ALTOONA CITY PLANNING COMMISSION

Regular Meeting of Tuesday, July 11, 2023 at 3:00 PM
4th Floor City Hall Common Room

Re: Grande Palazzo Phase 4 Preliminary/Final Land Development Plan (PTE #22131)

RESOLUTION 07-11-23-PAC23-04
A RESOLUTION CONDITIONALLY APPROVING
THE GRANDE PALAZZO PHASE IV
SUBDIVISION & LAND DEVELOPMENT PLAN

Grading Plan Enlargement
Scale: 1" = 10'

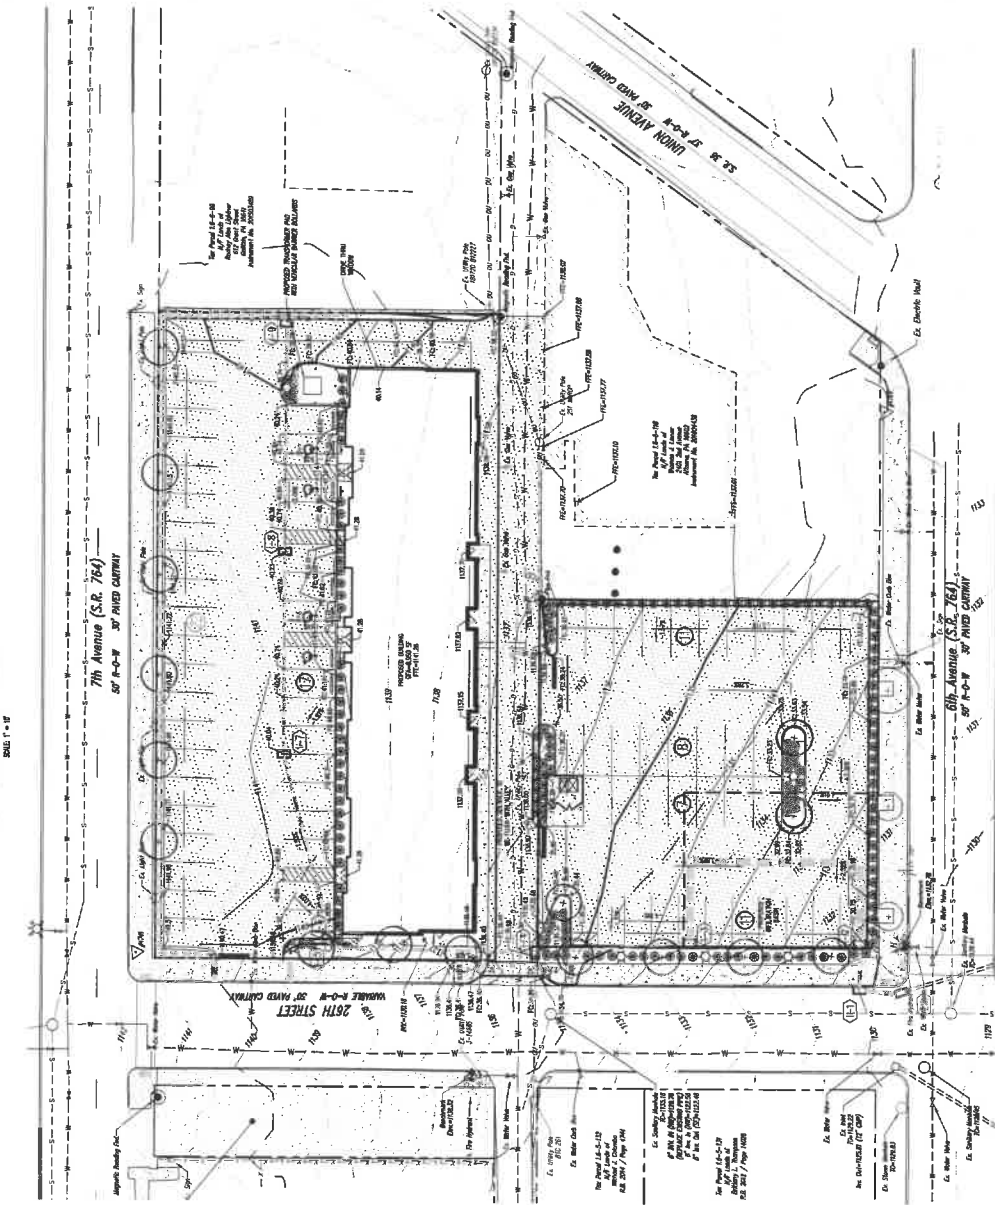
4. Please show contour labels on the grading plan.
 5. Blair County GIS has provided a new address of 118 Rosehill Drive for the funeral home. Please add this to the plans.

Contour labels added to sheet C4.

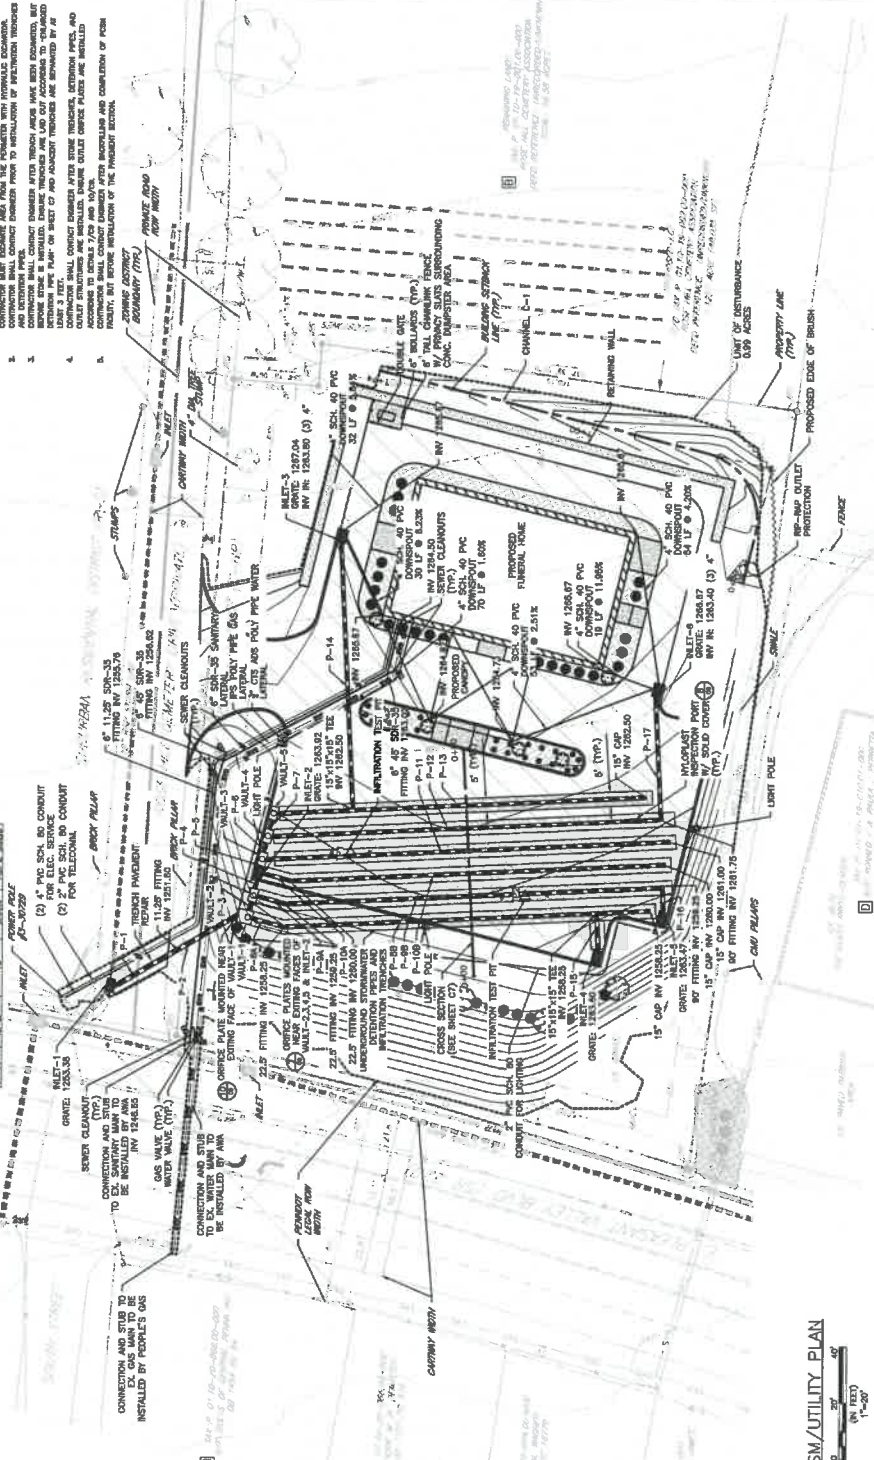
- Please provide a correlation between the naming convention on the plans of the underground detention (which is pipe labels with hatching around the pipe to distinguish the system) and that used in the report (which are labeled as Detention Pipe 1 – 5 and then just Detention Pipe without a number). Would highly suggest a detail of just a plan layout of the detention system showing where outlet structures are placed, etc.

- The current plan doesn't appear to indicate the trench lengths, which differ from the pipe lengths according to the report.
 - The outlet structure details do not appear to accurately depict the orifice described in the report. For example the plate could not be attached directly to the side of the box as the rectangle orifice would not function where it was not completely open to the 18" pipe. The secondary orifice is a rectangular orifice that is only 11" wide and 5" high in 5 of the scenarios but that is not indicated on the plan. It is just shown as a plate of undetermined width. Please revise details. Also note that the report indicates that DP 1-5 the 11"x5" is the top of plate, but in multiple facilities the 100-year storm elevation would exceed the 5" height, so this does not appear accurate. It would need to be a box like the other outlet pipe.

Detention Pipes in the PCSM report are renumbered to correspond with pipe numbers on the pipe schedule and plan. Additional enlarged Detention Pipe Plan view added to sheet C7 for clarity.

See infiltration trench schedule on sheet C5 for this information. Additional enlarged Detention Pipe Plan on sheet C7 shows the corresponding trench lengths and widths.

The orifice plate details are modified so show the orifice plate being held off the concrete face of each vault and instead attached to the sides of the vault box with angle iron. See Details 7/C9 and 10/C9 on sheet C9. The report and plan are updated to reflect the new dimensions of the low flow orifice, slot orifice, and top of plate weir. During small storm events the system will discharge through the ¾" or 1" orifice and through the 12"x4" or 14"x6" slot orifice, depending on the vault. Vaults 2, 3, 4, 5 and Inlet 2 have the orifice plate of detail 7/C9, where Vault 1, the last in series, has the orifice plate of detail 10/C9. During larger storm events the system will also discharge overtop of the plate, acting as a wier, but the 100-yr storm elevation of the system remains below the grate/rim elevation and does not pond water above ground.
